SUBJECT: Forwards application for amends to Licenses NPF-14 & NPF-22
 re App R ESW mods.

SUSQUEHANNA STEAM ELECTRIC STATION
PROPOSED AMENDMENT 123 TO LICENSE NO.
NPF-14 AND PROPOSED AMENDMENT 70 TO
LICENSE NO. NPF-22:
APPENDIX R ESW MODIFICATIONS
PLA-3180 FILES A17-2/R41-2

The purpose of this letter is to propose changes to both the Susquehanna SES Unit 1 and Unit 2 Technical Specifications. These changes are as a result of modifications being done to Susquehanna SES in order to comply with 10CFR50, Appendix R.

NOTE: THIS SIMPLIFIED DIAGRAM OF THE RR/SV/ESV SYSTEMS SHOWS FLOW PATHS, BUT DOES NOT PRESENT BRANCHES IN THEIR PHYSICAL ORDER.

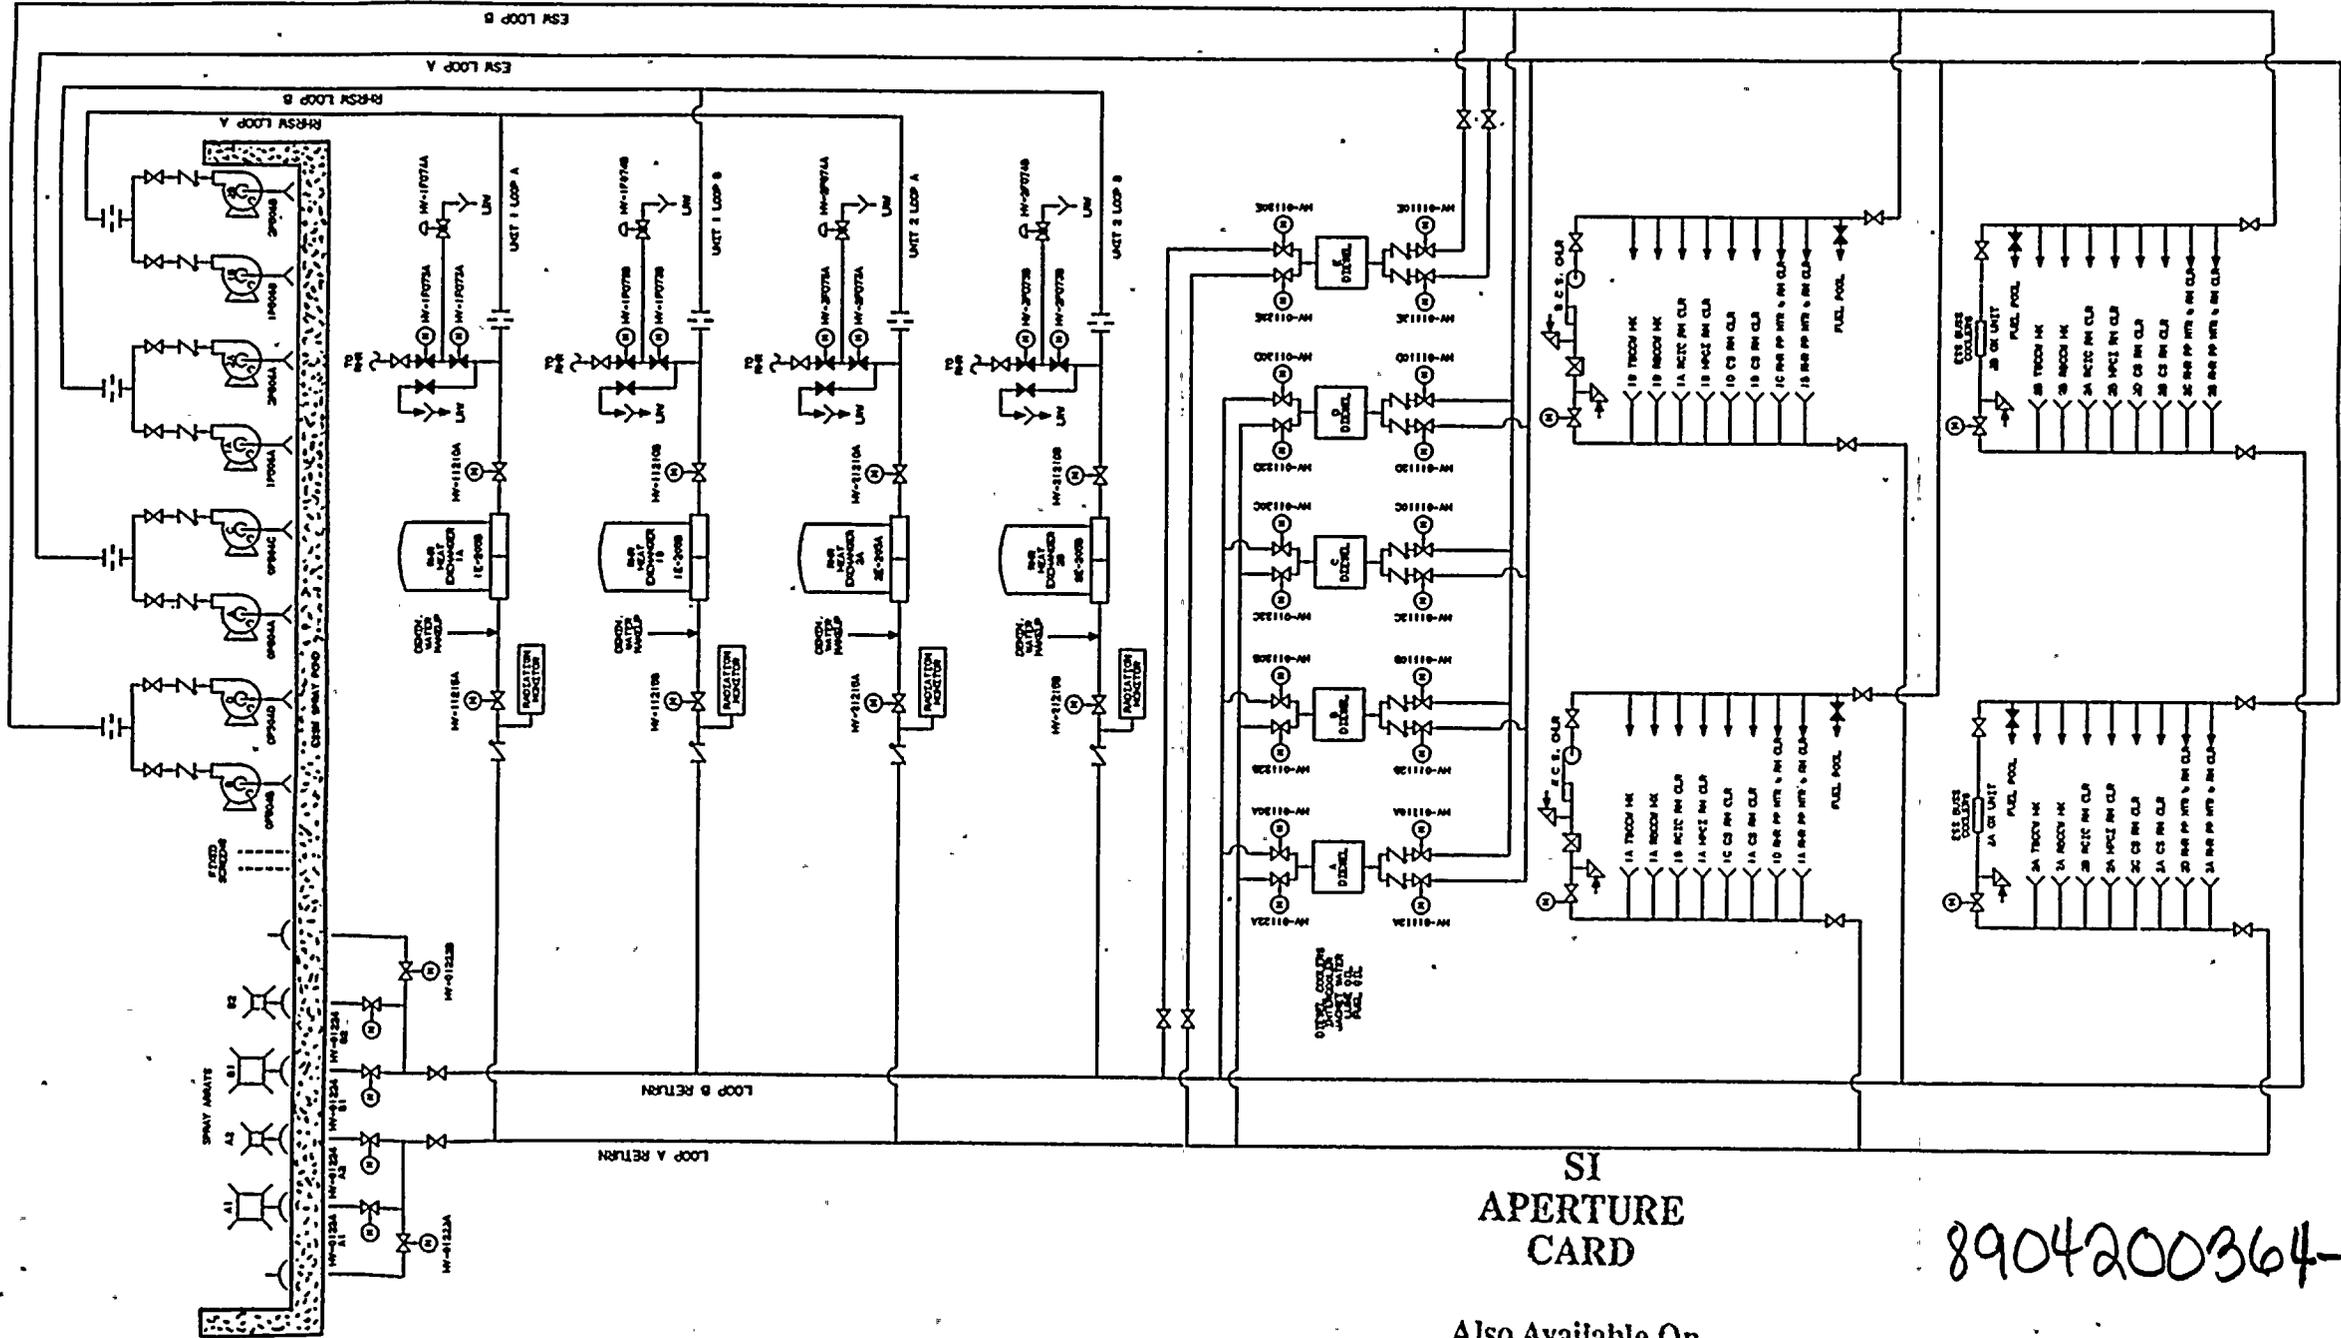
The proposed action is to modify the controls of the ESW valves for the Emergency Diesel coolers as follows:

1. The valve controls on Main Control Room Panel OC653 are removed. The valve position indicating lights are not removed so that the control room operator has valve position status for the aligned diesel generators. A fire in the control room can result in shorting the indicating lights which blows the control power fuse, but the valves will not change position once the modification is complete.

2. Local valve controls are added to the Engine Control Panel OC521 in Diesel Generators A through D bays and the Building Auxiliary Services Panel OC577E in the Diesel Generator E building. The local controls are used to close the ESW valves to isolate the diesel generator during maintenance and to open the valves when the diesel generator is aligned.

3. The auto-loop transfer logic is removed and both loops of the ESW System are normally aligned to the coolers of the four diesel generators in service.

4. Auto-closure logic is added to the Loop A valves of Diesel Generator E. The logic is the same as the existing Loop B logic which closes the valves and trips the output breaker if a LOOP and/or LOCA occur when the Diesel Generator E is not aligned but is being tested.

5. The continuous bypass of the thermal overload protection for the aligned diesel generators is deleted. Automatic bypass of the thermal overload protection is added to the Loop A ESW valves for Diesel Generator E when it is not aligned and is being tested.
